DA2020/0432

9-11 Birdwood Avenue Collaroy

Construction of a Seniors Housing or Housing for Persons with a Disability and Strata Subdivision

Development Determination Panel (DDP) for determination on Wednesday, 11 November 2020 at 10.00am.

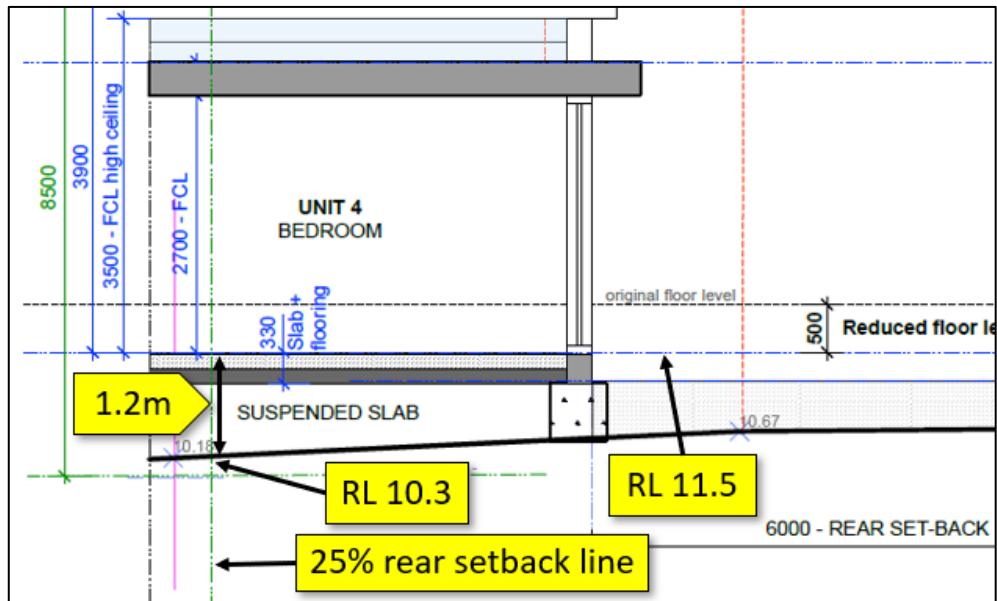
The SEPP (Housing for Seniors or People with a Disability) "Rear 25%" of the proposed development still represents a two-storey volume, as the floor below is still more than 1m above the existing ground level at the 25% rear setback line.

SEPP control, Chapter 3, Part 4, Division 1, Clause 40(c) states: *"a building located in the rear 25% area of the site must not exceed 1 storey in height."*

The proposed reduction by 0.1m from RL 11.5 to RL 11.4, is set against the elevation at the 25% rear setback line shown on the Applicant's section plan (DA.20) as approximately RL 10.3 (highlighted in the diagram on the next page) which is 1.2m below the upper ground floor height of RL 11.5.

A reduction of the upper ground floor level to be reduced by 0.3m from RL 11.5 to RL 11.2 making it 0.9m above natural ground level (RL 10.3) and hence will not be calculated as a storey and demonstrate compliance with SEPP, with the overall roof levels reduced from RL 15.4 to RL 15.1 (reduction of 0.3m) and lower roof level from RL 14.55 to RL 14.25 (reduction of 0.3m).
